Putts Bridge Hydroelectric Project  
(FERC No. 10677) Water Quality Study

**PUTTS BRIDGE HYDROELECTRIC PROJECT**  
**FERC NO. 10677**

**WATER QUALITY MONITORING STUDY REPORT**

**FIGURE 1**

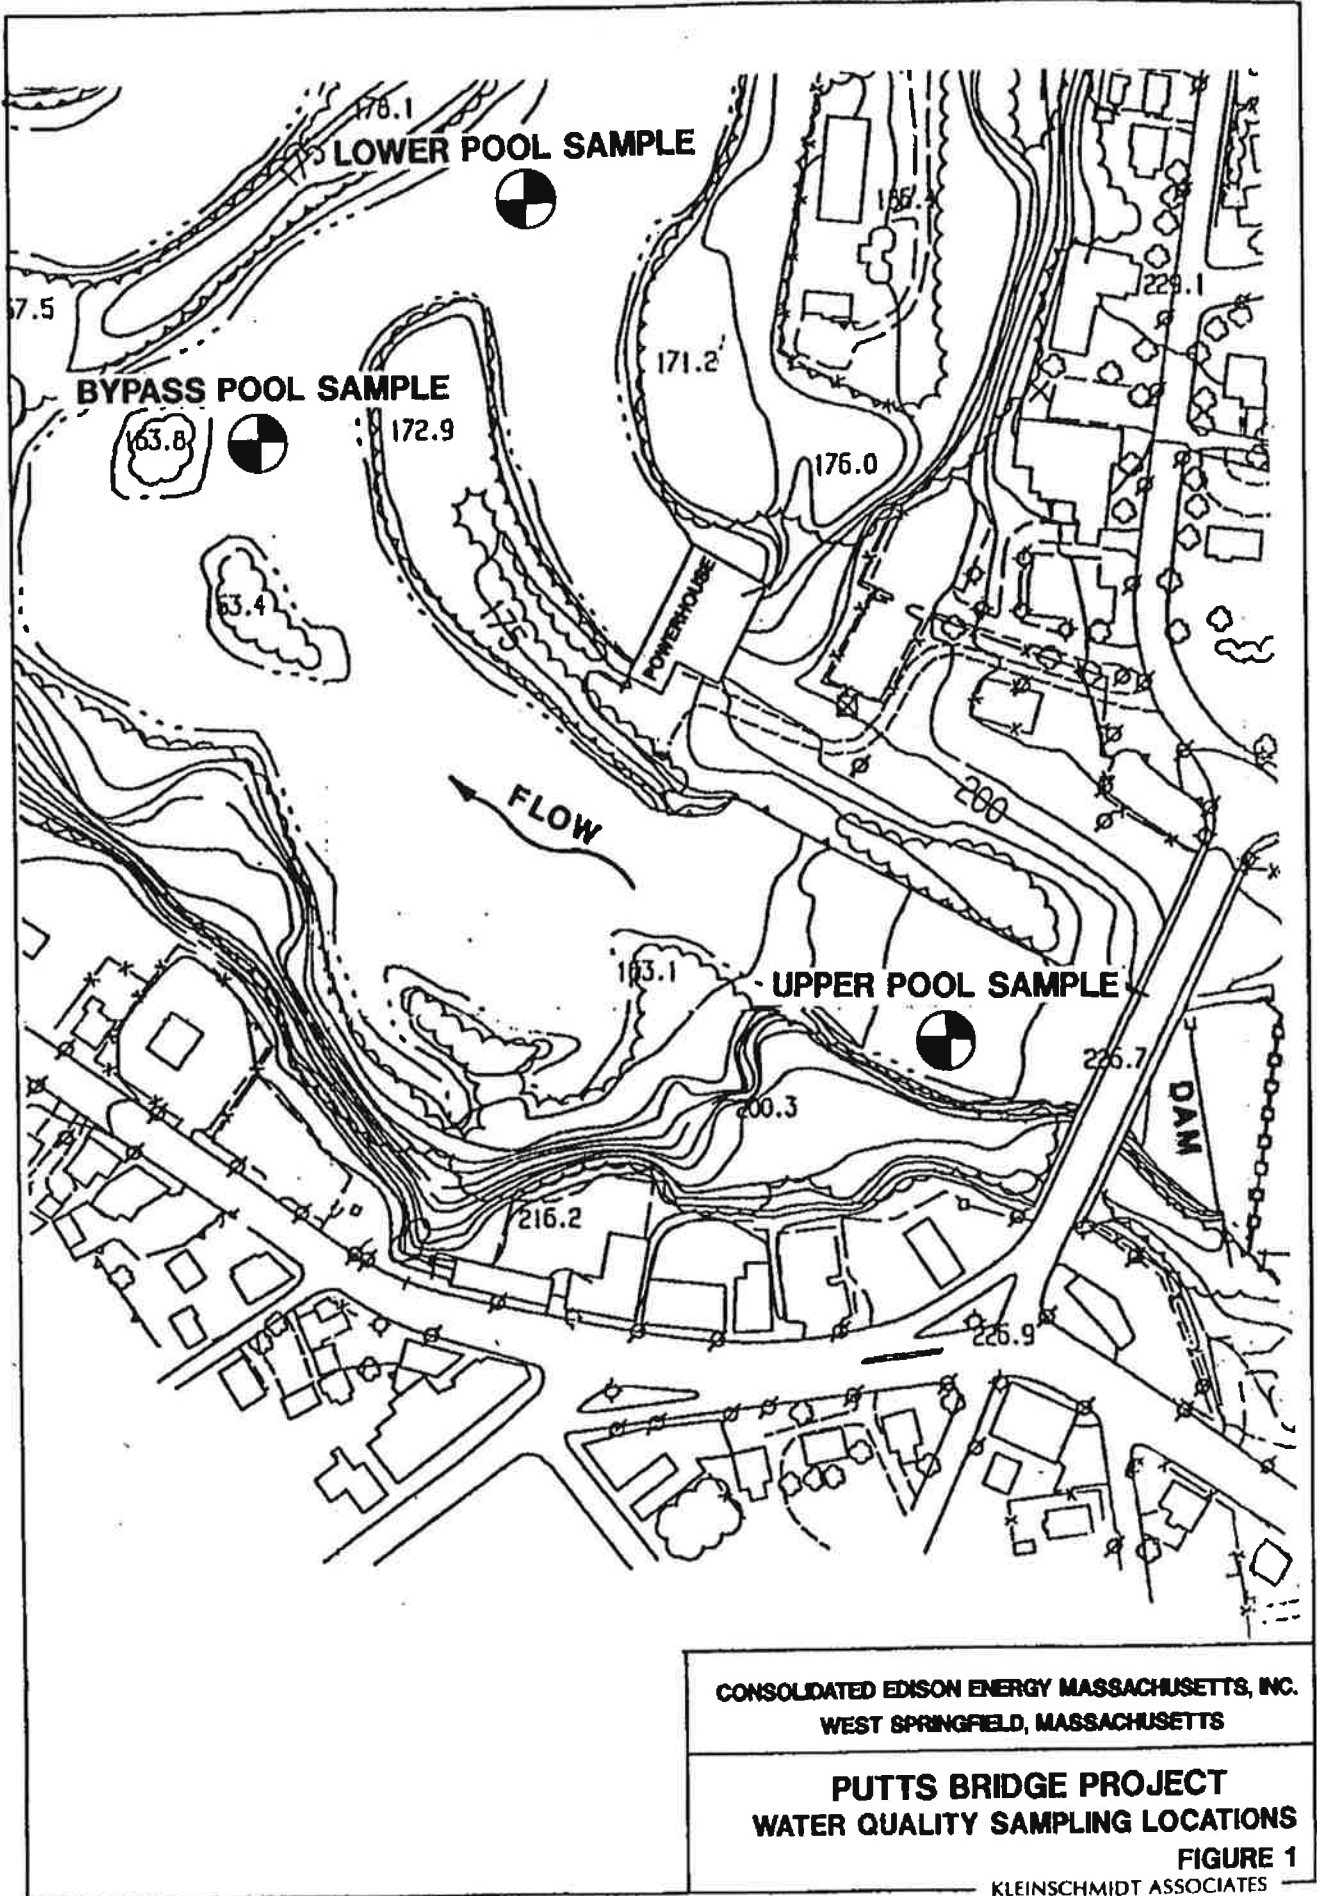
Your proposal to sample the water temperature and dissolved oxygen twice daily during July and August at two locations in the bypass reach and at one location at the confluence of the tailrace is acceptable. We would recommend that the sampling occur at least twice a week in the period July through August, and that the sampling occur during normal summer low flow conditions. Please avoid sampling when the project is spilling into the bypass reach, and provide a summary of bypass reach flow data that corresponds to the water quality sample times.

We have no objection to the proposed study protocol. However, the plan does not specify how many times each week samples will be collected. We recommend that monitoring take place a minimum of twice per week. Also, sampling should take place during the warmest, driest conditions possible (e.g., avoid sampling during or after precipitation events). If higher flows are evaluated, you will need to provide a calculation sheet that verifies how much flow was passed during that monitoring event.

Water quality monitoring consisted of in-situ measurements of DO and temperature collected from the bypassed reach. Sampling was performed at three locations including 1) the upper bypass reach immediately downstream of the spillway, 2) the lower bypass reach, and 3) just downstream of the confluence of the tailrace and bypassed reach. (Figure 1). Sampling was performed at the deepest portion of each sampling location. Each site were sampled twice each week from July 8 to September 6, 2000 (total of 8 weeks). Sampling did not commence during the first week of July due to river conditions at the site. In order to collect data for 8 consecutive weeks, sampling was continued through early September. Sampling events did not occur during consecutive days during the week. Each sampling event included diurnal collections (morning and evening). Morning samples were collected within approximately 2 hours after sunrise and evening sampling were conducted within approximately 2 hours before sunset. If depths within
